Subject: Notification of a Class 1 Permit Modification to the Waste Isolation Pilot Plant  
Hazardous Waste Facility Permit Number: NM4890139088-TSDF

**Class 1 Permit Modification Notification**

**Update Panel Closure Information**

**Waste Isolation Pilot Plant  
Carlsbad, New Mexico**

**Figure A2-1**  
**Repository Horizon**

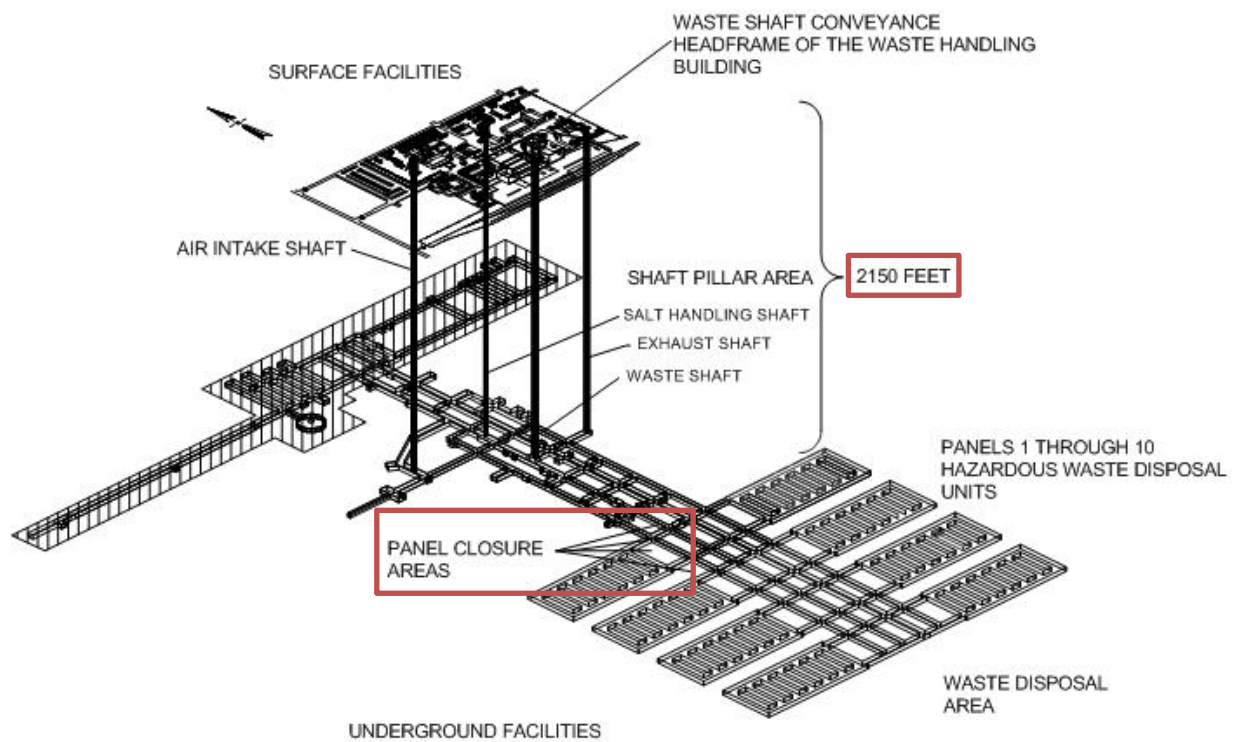
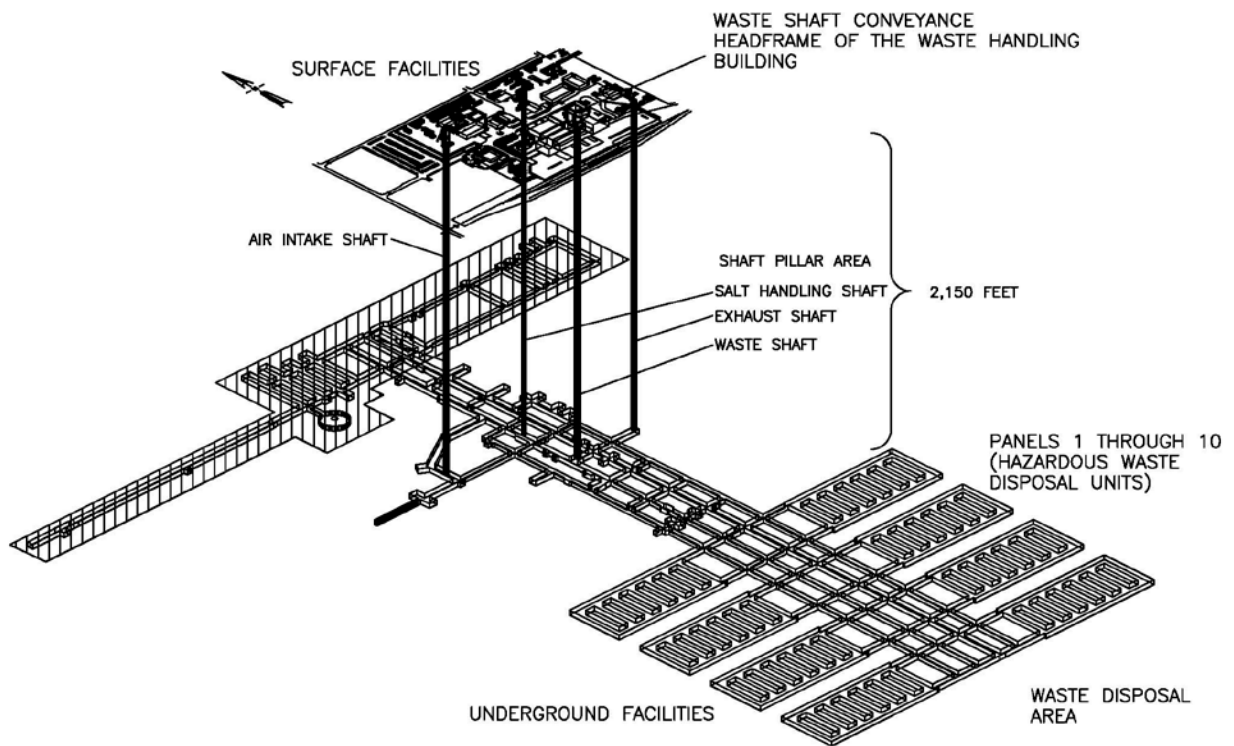
- Permit Attachment A2, Figure A2-1, *Repository Horizon*; Permit Attachment B, Figure B3-2, *Repository Horizon*; Permit Attachment D, Figure D-7, *Designated Underground*

- Changed “AREA DESIGNATED FOR ACCESS MAIN CLOSURES” to “EXISTING PANEL CLOSURE” in the figure legend.
- Removed “AREA DESIGNATED FOR PANEL ENTRY CLOSURES WITHOUT EXPLOSION-ISOLATION WALLS” from the figure legend.

- Changed “AREA DESIGNATED FOR PANEL ENTRY CLOSURES WITH EXPLOSION-ISOLATION WALLS” to “FUTURE PANEL CLOSURE” in the figure legend.
- Revised the markers on the underground layout to correspond with the new figure legend as follows:

- Changed the markers for the Panels 1, 2, 7, 8 and 10 closures to future panel closures.
  - Changed the markers for Panel 9 to existing panel closures.

- Removed the markers for Panels 3 through 6.
- Permit Attachment A2, Figure A2-2, *Spatial View of the Miscellaneous Unit and Waste Handling Facility*, Permit Attachment B, Figure B3-1, *Spatial View of the WIPP Facility*, and Permit Attachment D, Figure D-2, *Spatial View of the WIPP Facility*

**Figure A2-2**  
**Spatial View of the Miscellaneous Unit and Waste Handling Facility**

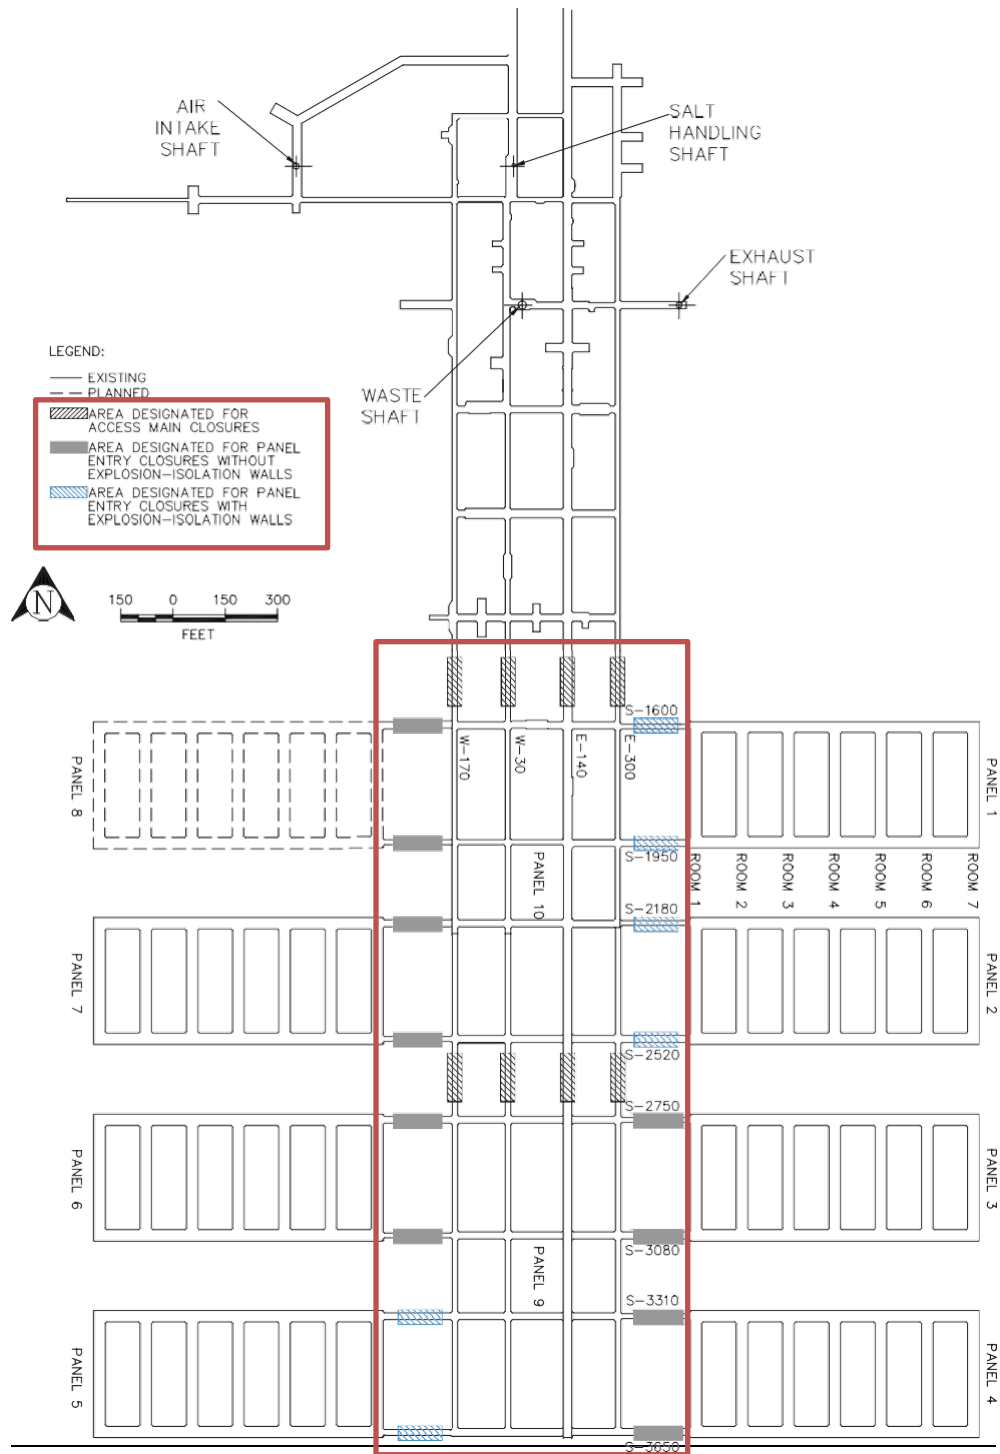
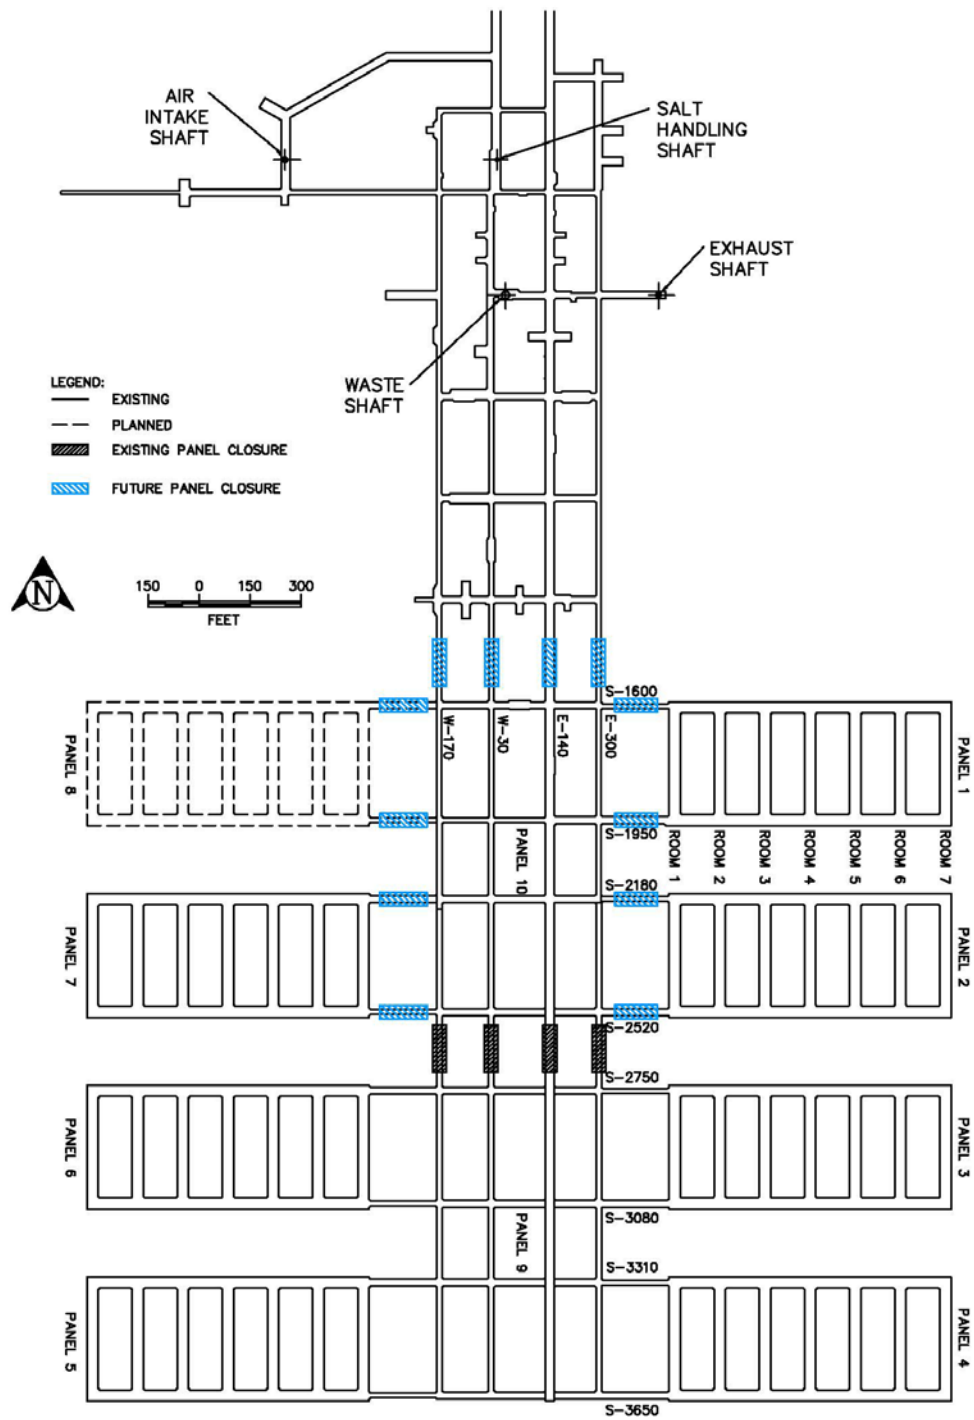
- Removed the panel closure label.
  - Added a comma to “2150” to read “2,150.”
- Permit Attachment G, *List of Figures*
  - Changed the figure title from “Location of Underground HWDUs and Anticipated Closure Locations” to “Location of Underground HWDUs and WPC Locations.”

**Figure G-1**  
**Location of Underground HWDUs and Anticipated WPC Locations**

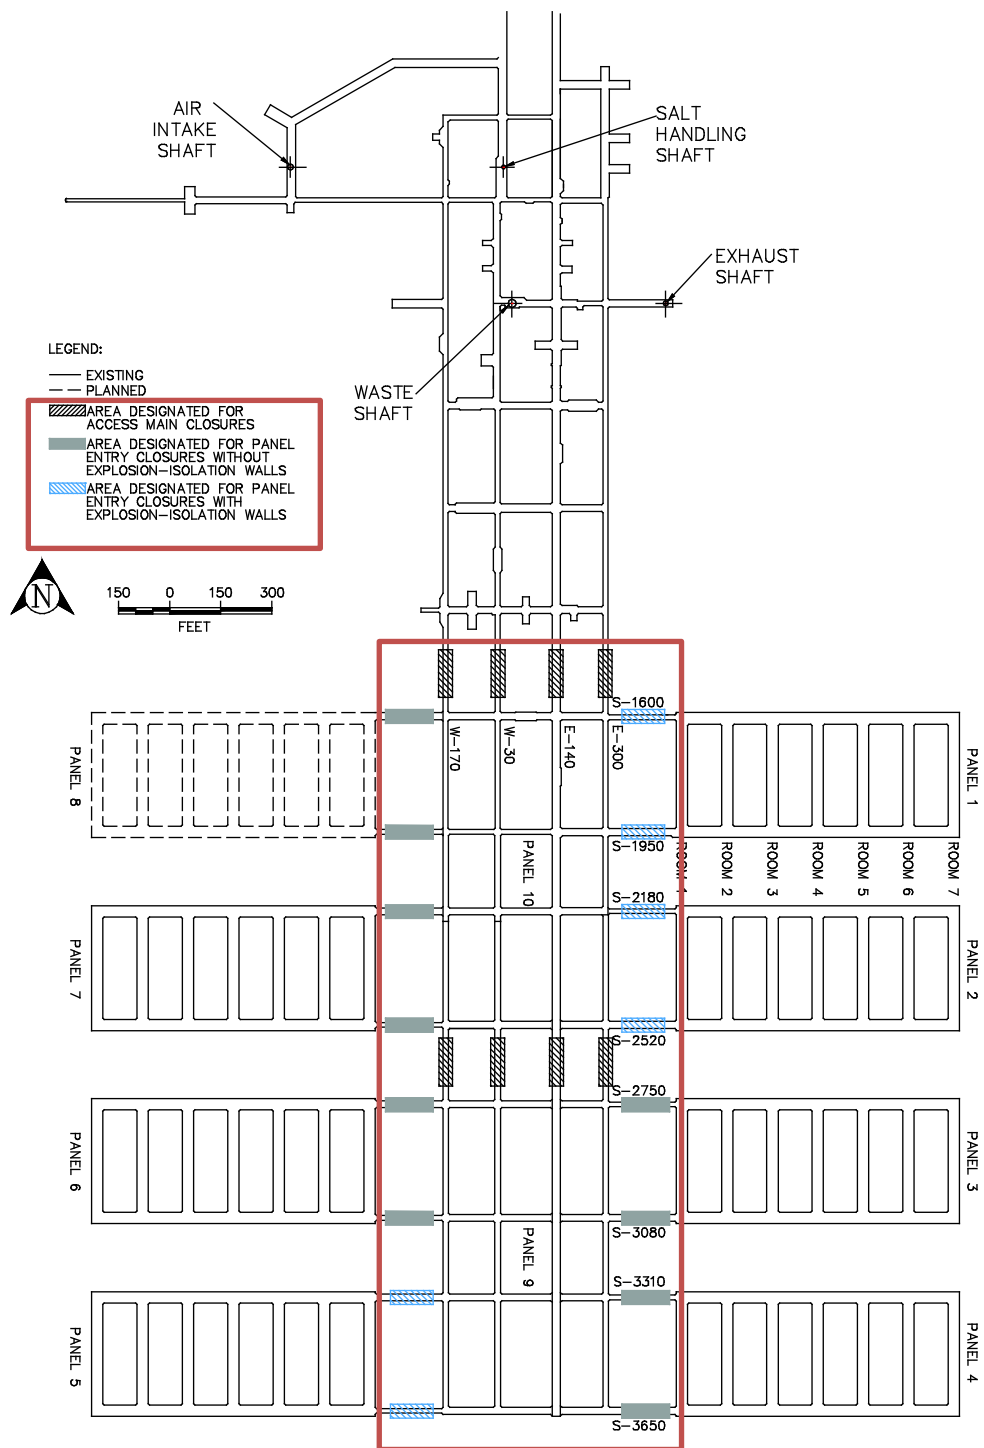
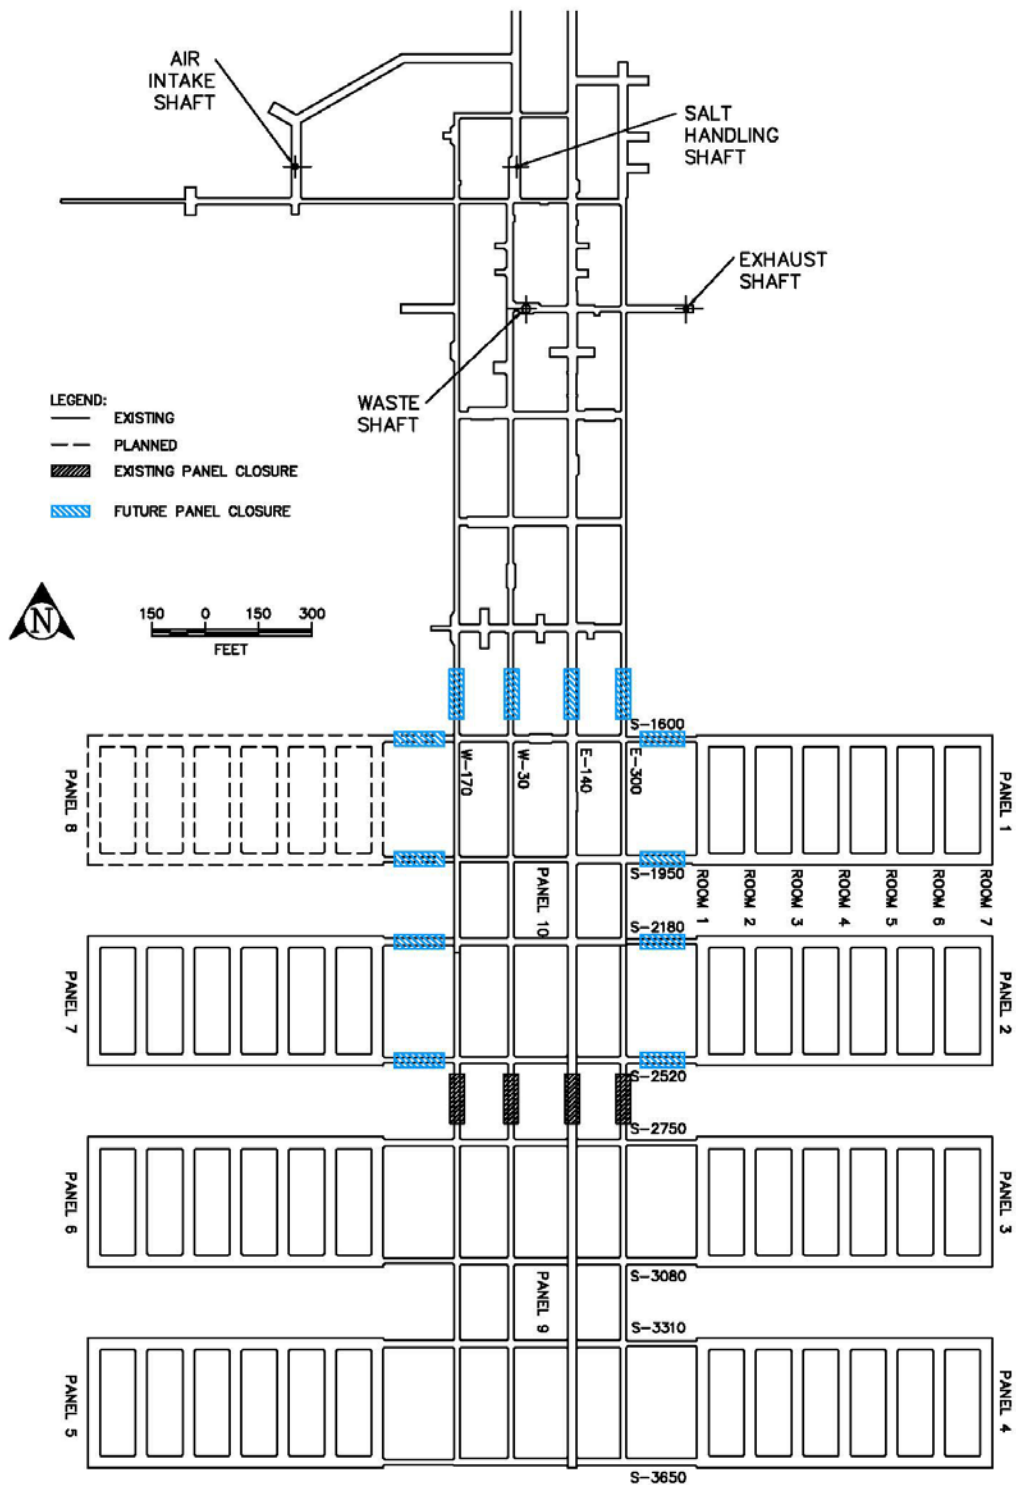
*Assembly Areas; Permit Attachment G, Figure G-1, Location of Underground HWDUs and Anticipated WPC Locations; Permit Attachment G, Figure G-6, Approximate Locations of Boreholes in Relation to the WIPP Underground*

- Permit Attachment G, Figure G-1, *Location of Underground HWDUs and Anticipated WPC Locations* also change the following:
  - Changed the figure title from “Location of Underground HWDUs and Anticipated WPC Locations” to “Location of Underground HWDUs and WPC Locations.”

**Figure G-6**  
Approximate Locations of Boreholes in Relation to the WIPP Underground

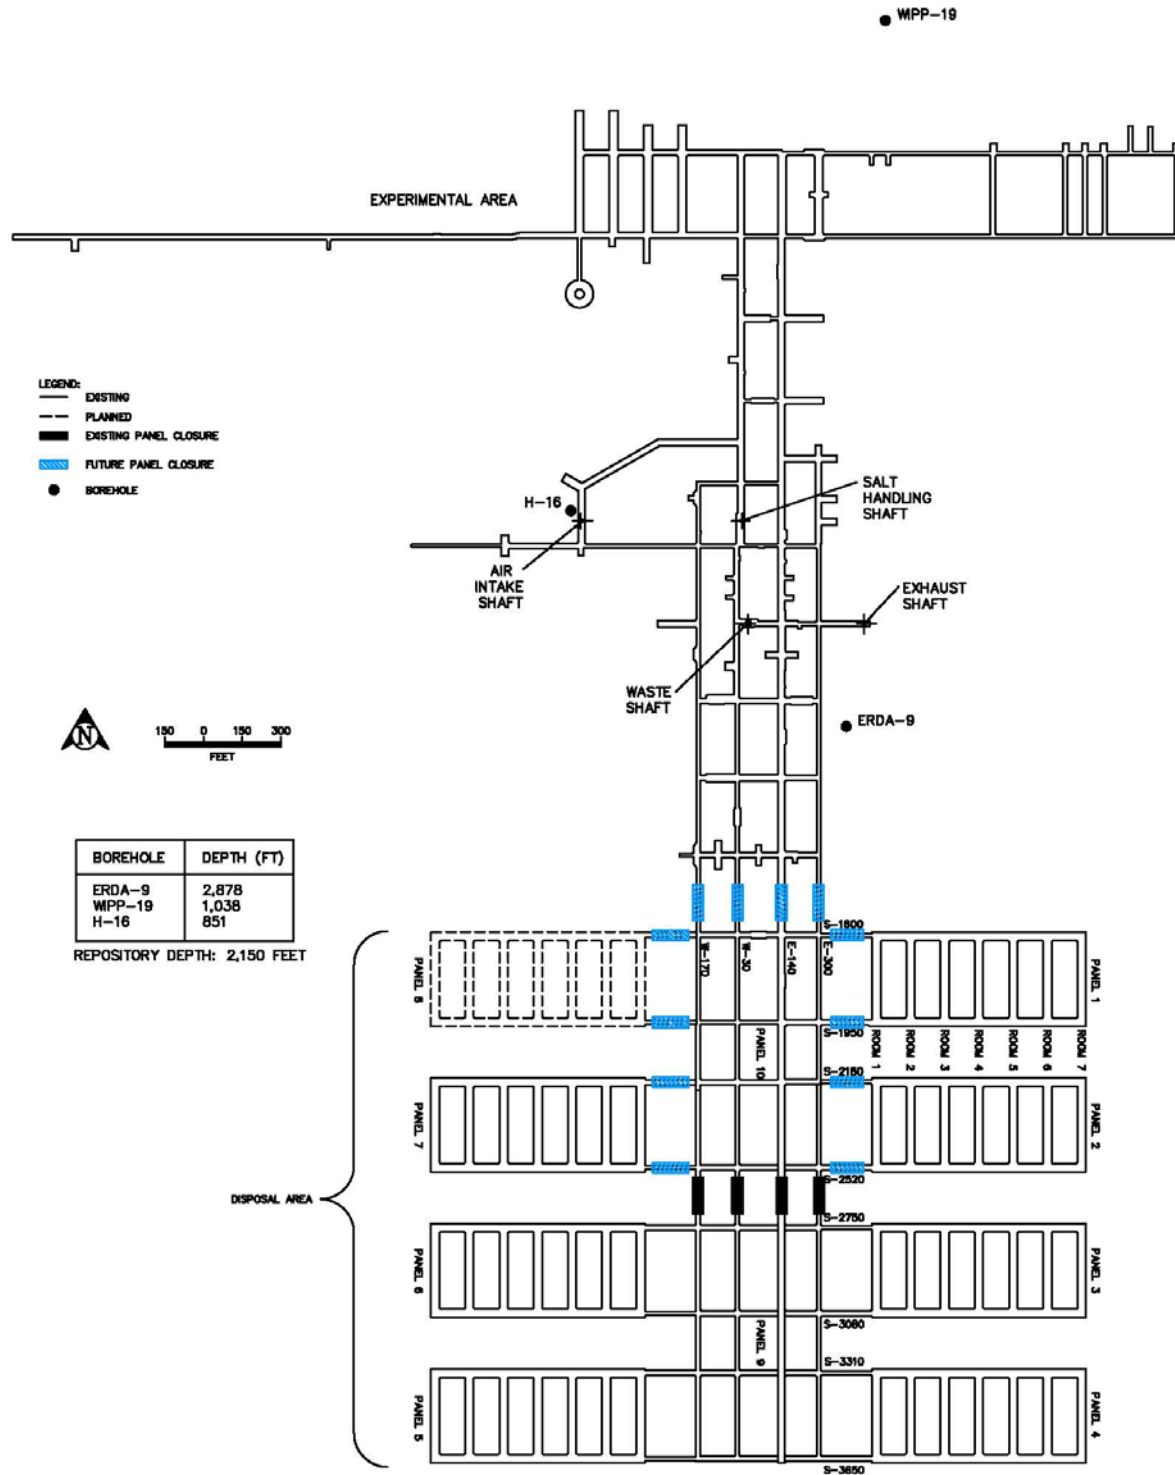
- Permit Attachment G, Figure G-6, *Approximate Locations of Boreholes in Relation to the WIPP Underground* also make the following editorial changes:
  - Added a comma to “2878” to read “2,878.”

- Added a comma to “1038” to read “1,038.”
  - Added a comma to “2150” to “2,150.”
  - Removed “BORE HOLE” from the ERDA-9 label to be consistent with the other borehole labels.
